Burlington Design Advisory Board

DESIGN ADVISORY BOARD Tuesday, April 26, 2022 3:00 PM

To: Design Advisory Board
From: Scott Gustin
Re: 352 South Winooski Avenue
Date: April 26, 2022

To: Design Advisory Board
From: Scott Gustin
Re: 48 Sunset Cliff Road
Date: April 26, 2022

3 SILL & HEAD DETAIL
SCALE: 1-1/2" = 1'-0"

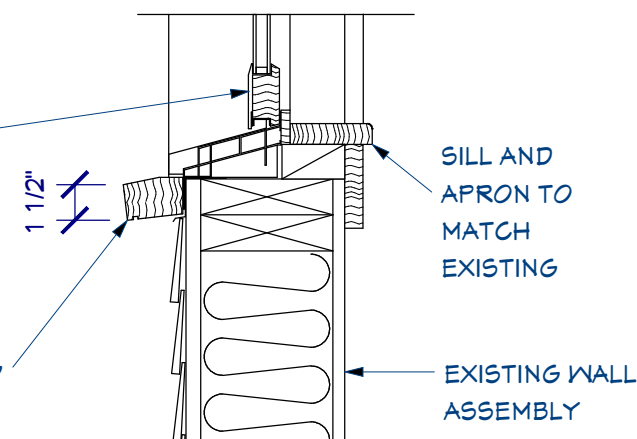
The applicant has provided sill and head details for installation of the proposed replacement windows. Exterior wood window casings will match the existing, and the proposed sills will be built out with wooden detail to match the existing. The proposed detailing associated with the replacement windows closely matches the existing conditions and appears to be acceptable.

Approval of the proposed replacement windows contingent on installation details as depicted in the revised project plans.

Title
LANDSCAPE PLAN

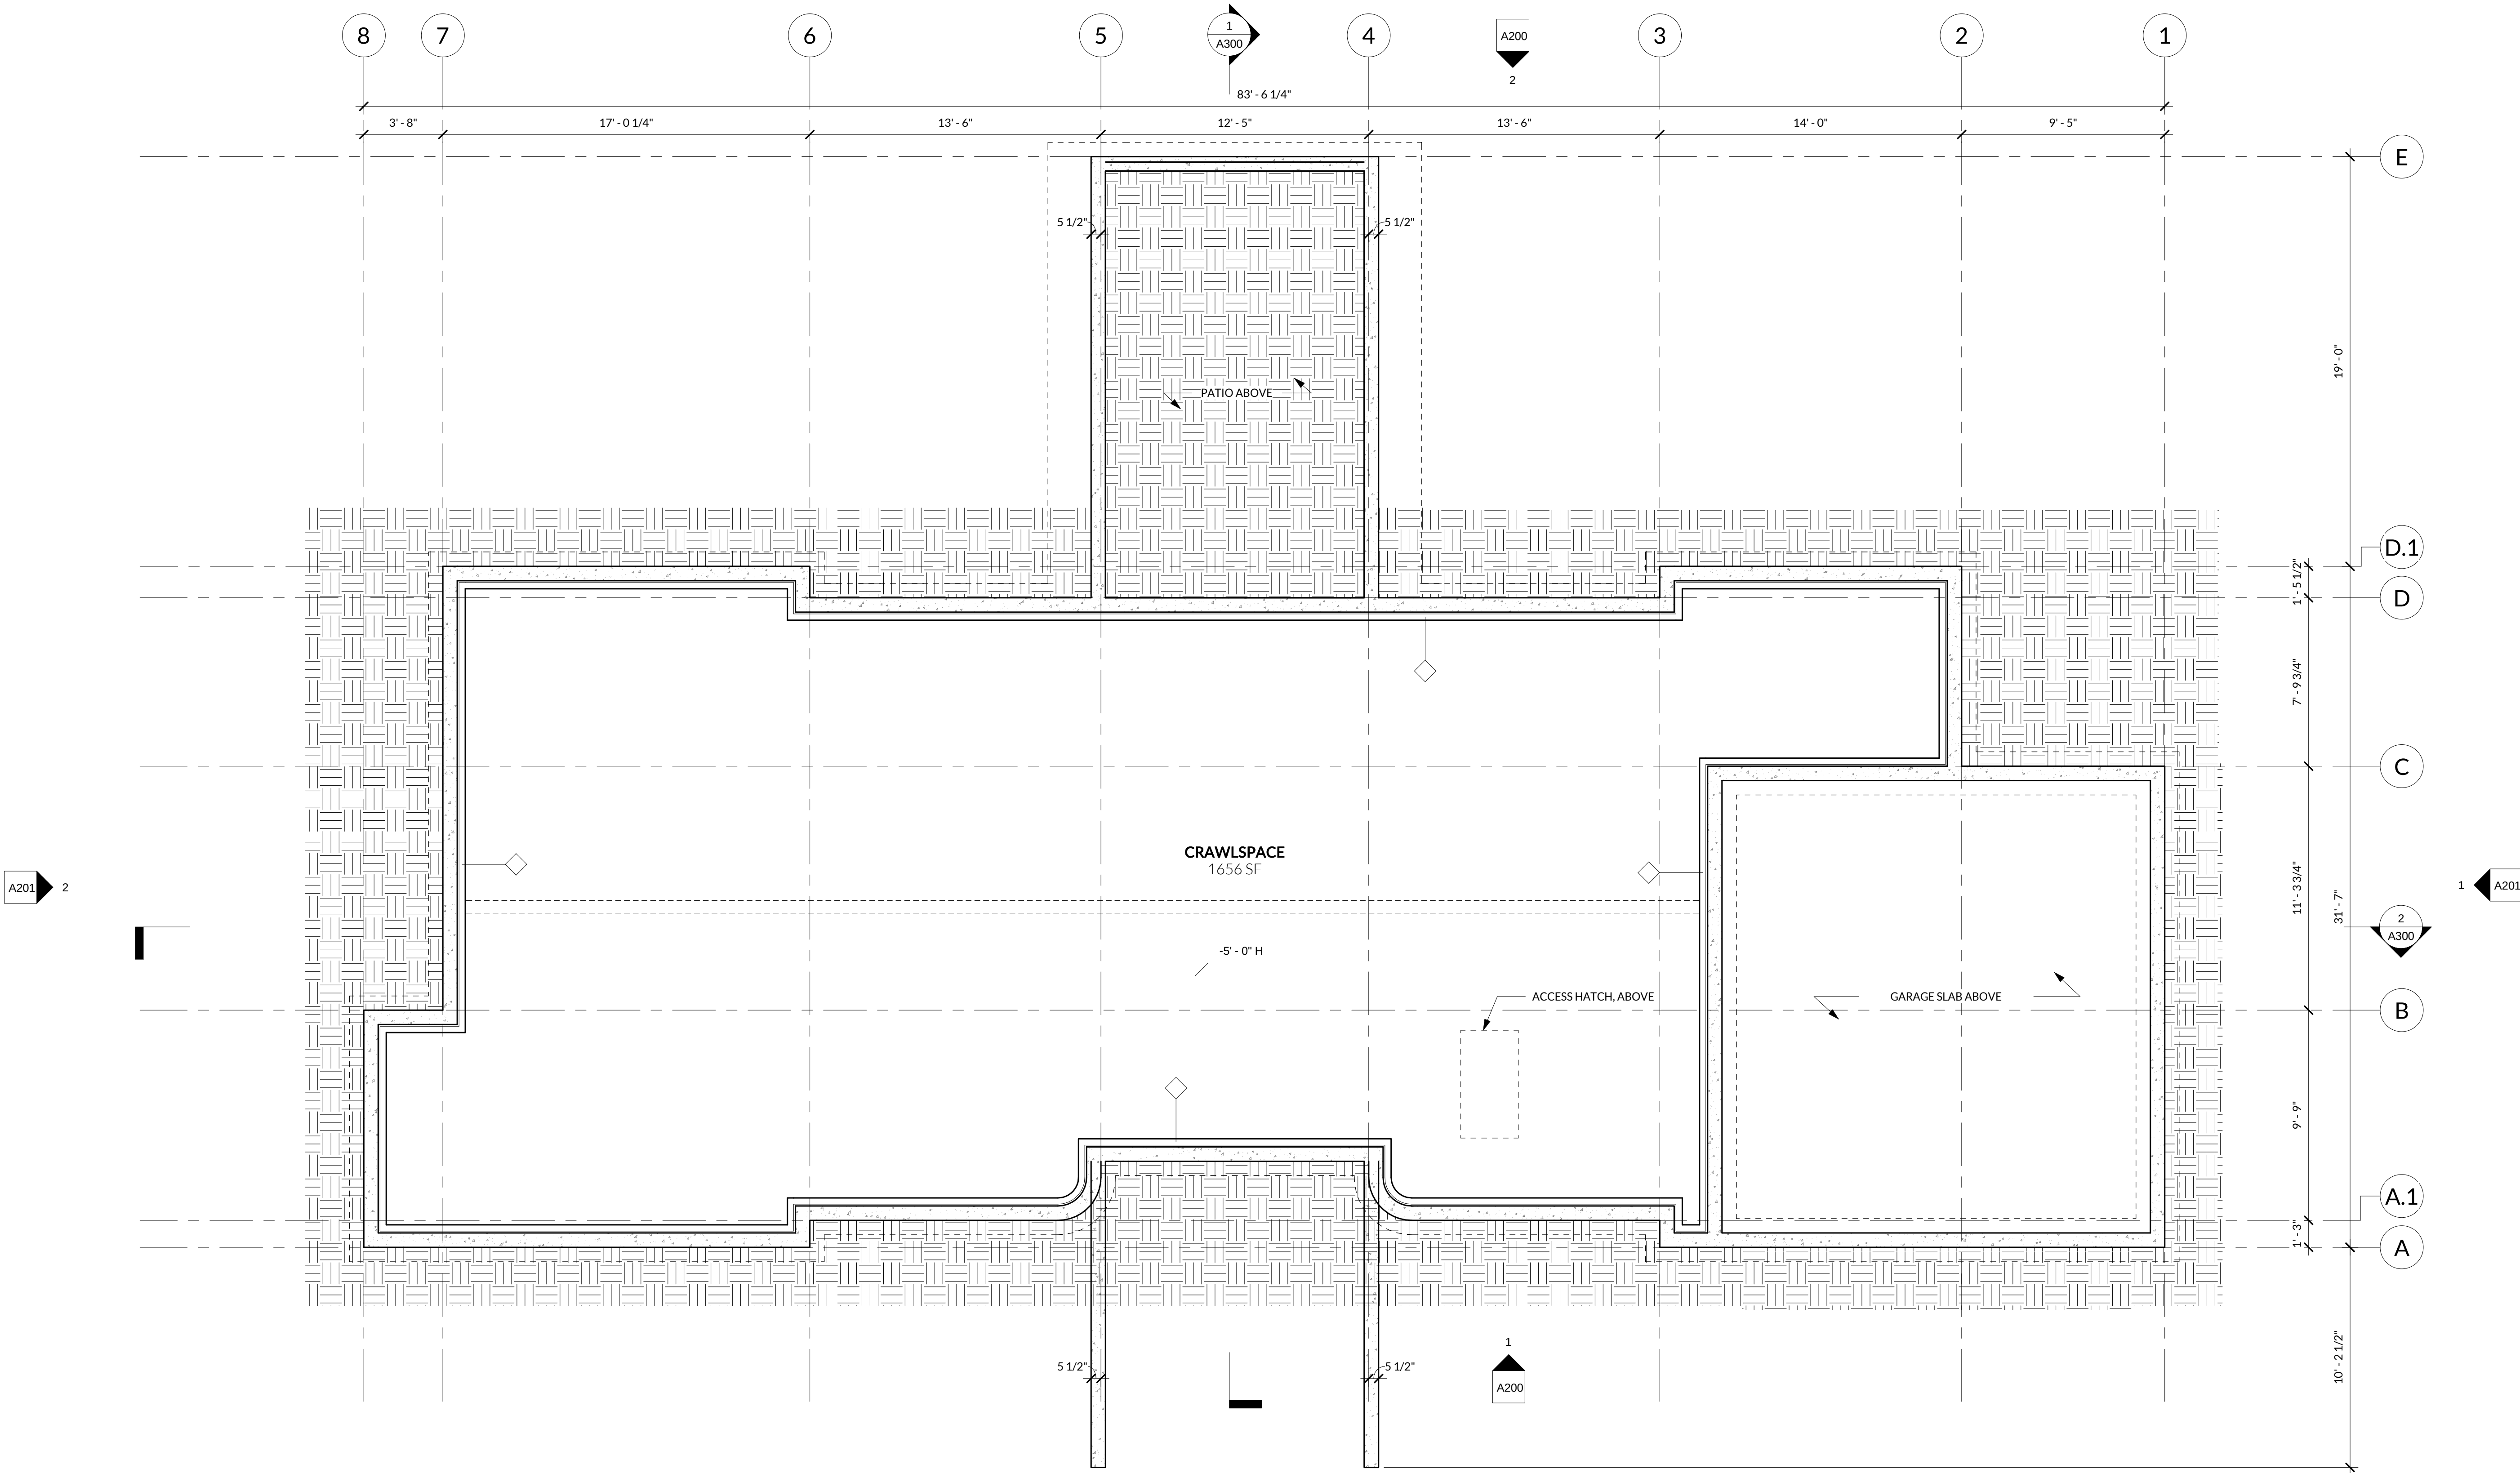
Most existing mature vegetation will be retained. As noted above, a low-mow zone will be established along the property's lakeshore. The proposed landscaping plan depicts a variety of new plantings to accent the building and its front entrance. Additional plantings are proposed along the side property lines as well. Proposed species are not invasive and appear to be acceptable.

LEVEL 1	1/4" = 1'-0"	1	
			A200	A100

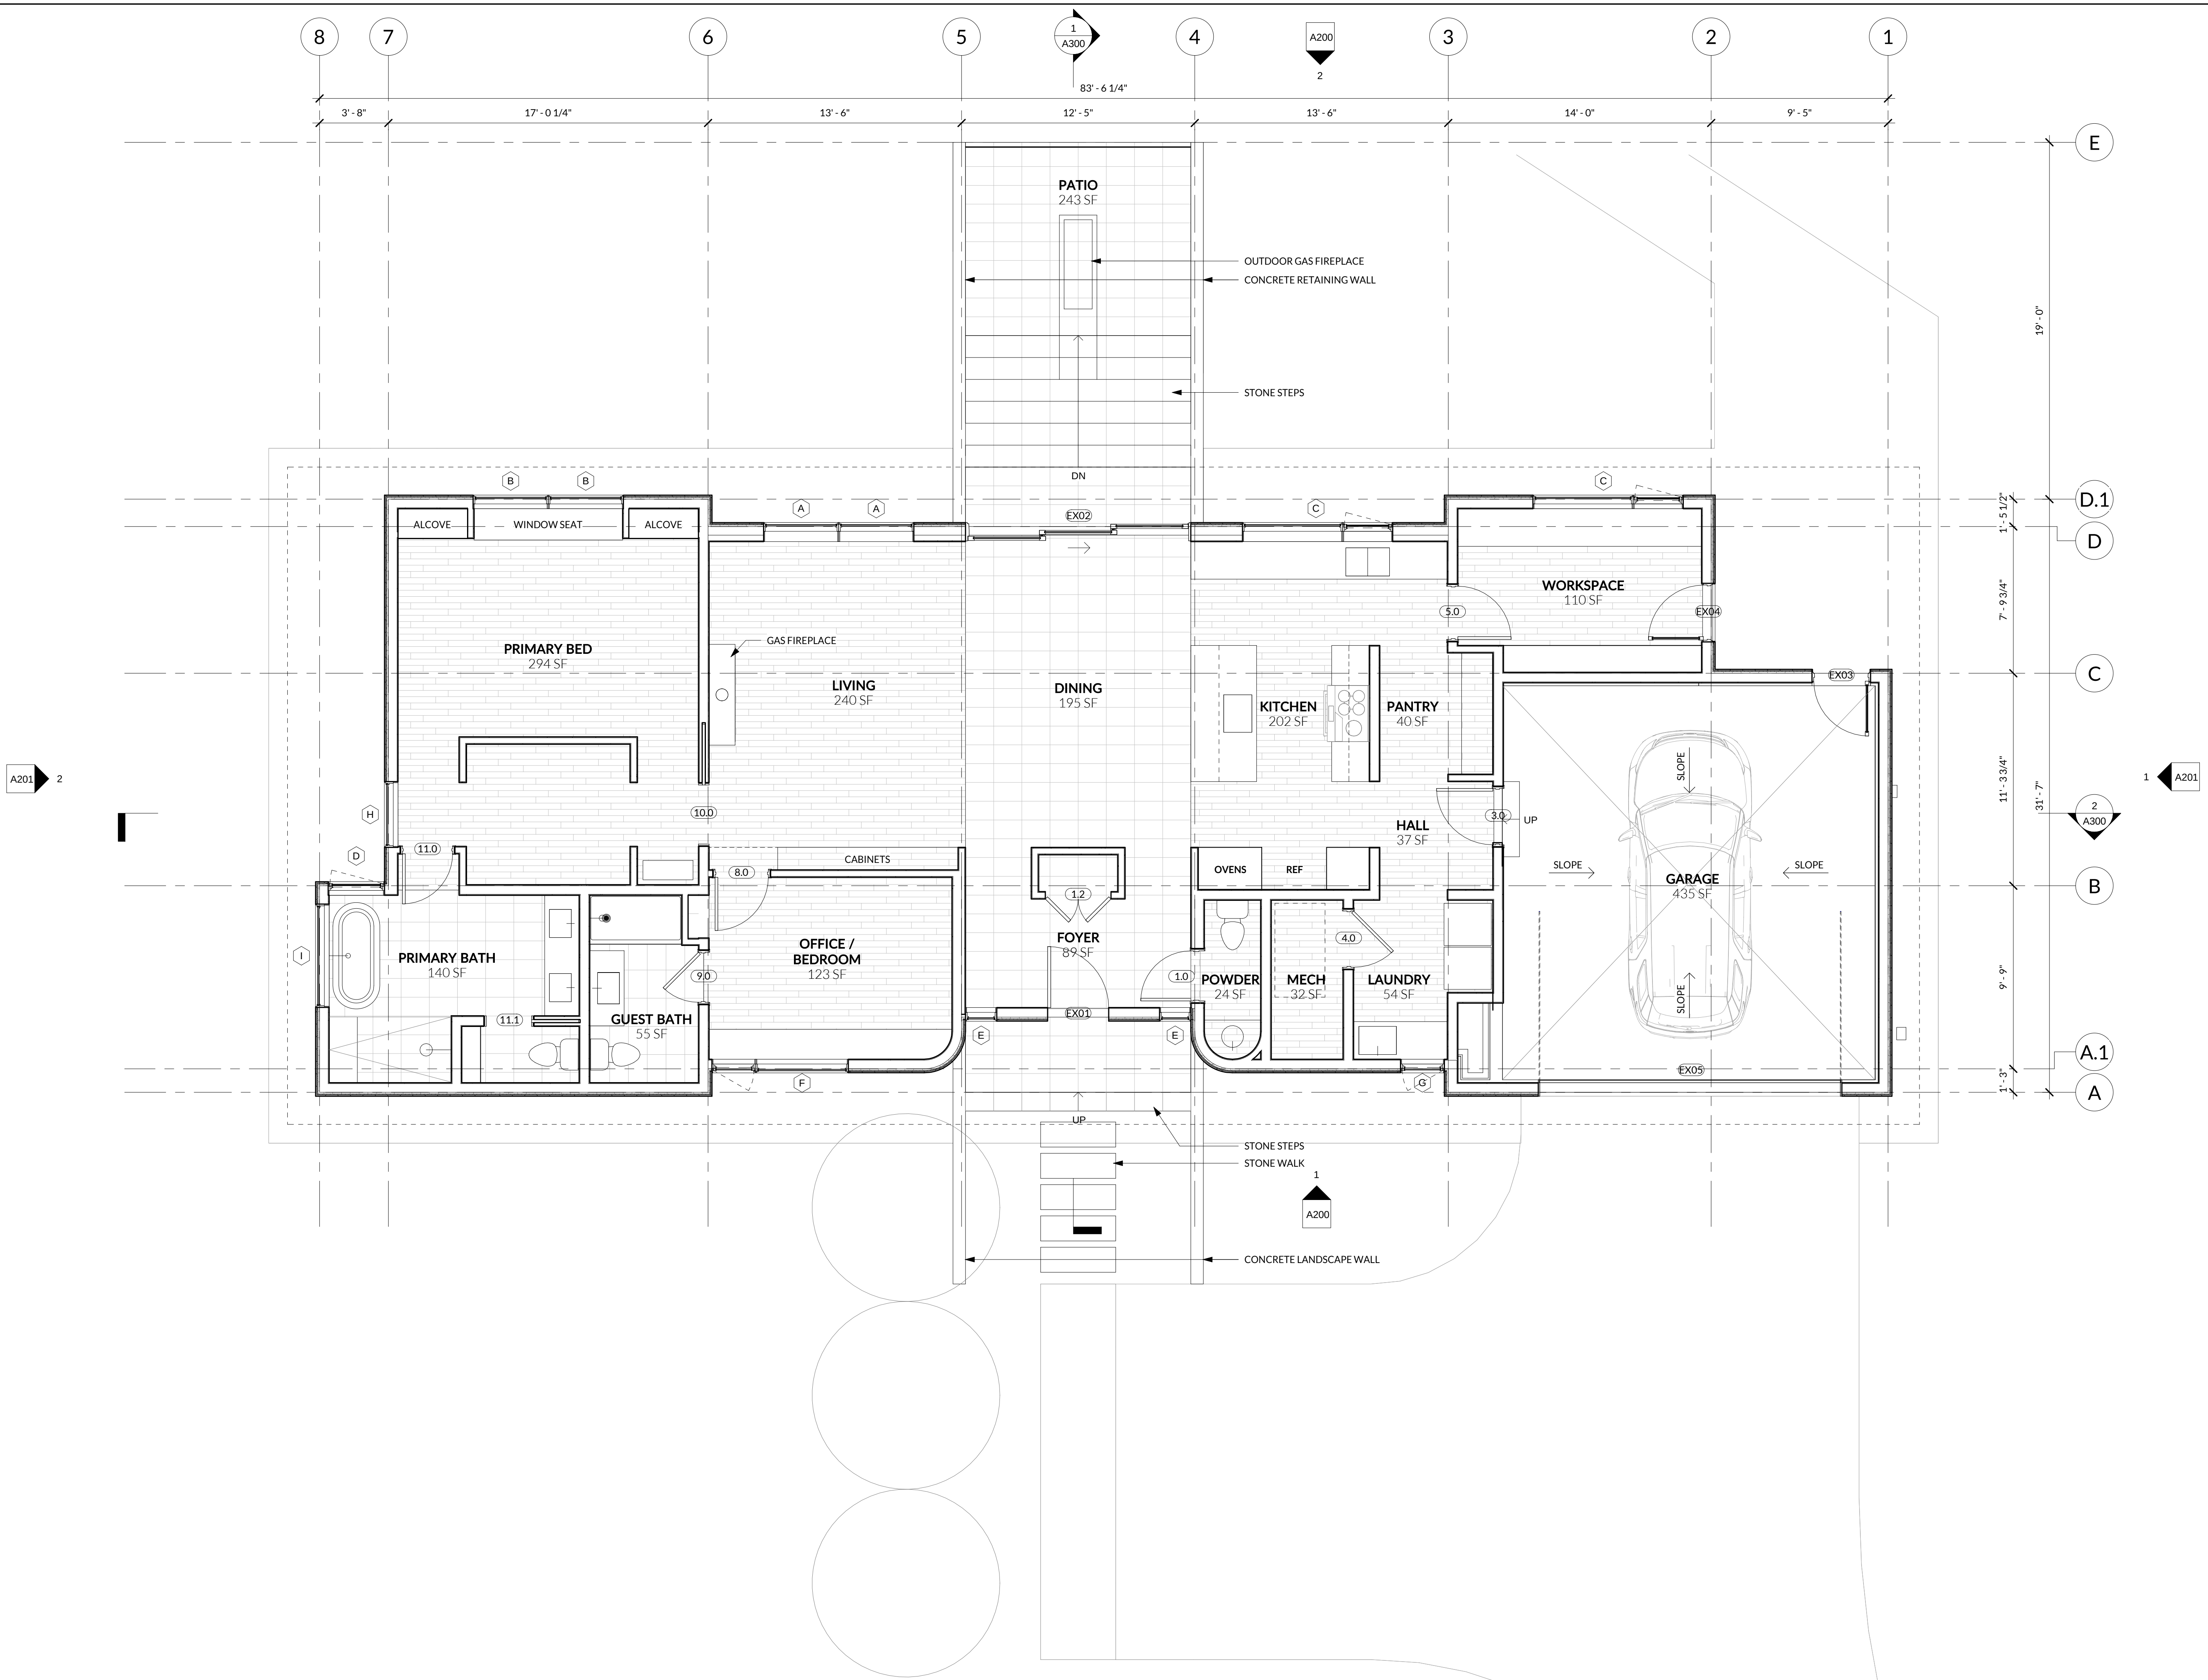
This criterion calls for setting garages behind the longest front facing wall of the residence. The intent is for the garage to have a location secondary to that of the residence. As proposed, the attached garage appears to be flush with the front line of the residence. Revision is needed in order to push the face of the garage behind the longest street-facing wall of the home.

The proposed driveway extends in front of half of the home and is well over 18' wide. A narrowed turn-around to the north of the residence (opposite the currently proposed location) may be acceptable. Reconfiguration of the front walk would be needed.

1. Revised project plans addressing the following are needed:
 - a. Adjustment of the attached garage to be set behind the longest street-facing wall of the residence;
 - b. Adjustment of the driveway to avoid extension in front of the house and limits width to 18 feet;
 - c. Depiction of outdoor lighting fixture locations; and,
 - d. Depiction of any exterior mechanical equipment and related screening.

- A. Install the garage door flush with the face of the surrounding wall plane, in which case the location of the proposed is acceptable.
 - B. Move the 39' wide center portion of the front façade forward so that it is proud of the garage wall.
 - C. Move the left hand wall of the front façade forward so that it is proud of the garage wall.
2. Recommend to increase the depth of the roof eaves on the front façade to be 24" min.
 3. Decrease the width of the driveway to be no wider than 18'-0".
 4. At the front patio, use a material that is different and distinct from the driveway.
 5. Depict outdoor lighting fixture locations and mechanical equipment per staff comments.
